NUMBER: 02-006-14

Front Suspension Clunk Noise While Making Left And Right Turns

This bulletin involves replacing the front strut jounce bumpers.

2012 - 2015 (FF) 500

Fig. 1 Strut Assembly

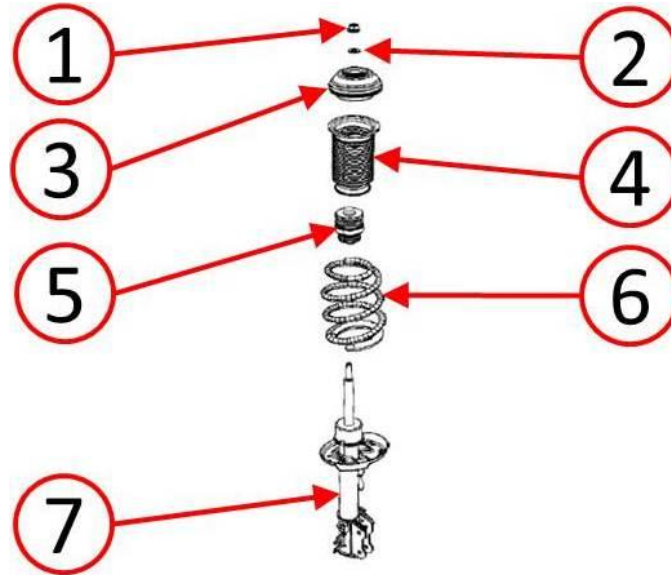
4. Disassemble the front strut assemblies. Refer to the detailed service procedures available in DealerCONNECT> TechCONNECT under: Service Info> 02 - Front Suspension> Front> STRUT, Suspension, Assembly> Disassembly.
5. Discard the old jounce bumpers (5) (Fig. 1).
6. Assemble the front strut assemblies with the **NEW** jounce bumpers (5) (Fig. 1). Refer to the detailed service procedures available in DealerCONNECT> TechCONNECT under: Service Info> 02 - Front Suspension> Front> STRUT, Suspension, Assembly> Assembly.
7. Install the front strut assemblies. Refer to the detailed service procedures available in DealerCONNECT> TechCONNECT under: Service Info> 02 - Front Suspension> Front> STRUT, Suspension, Assembly> Installation.

Qty.	Part No.	Description
2	68073020AC	Front Jounce Bumper
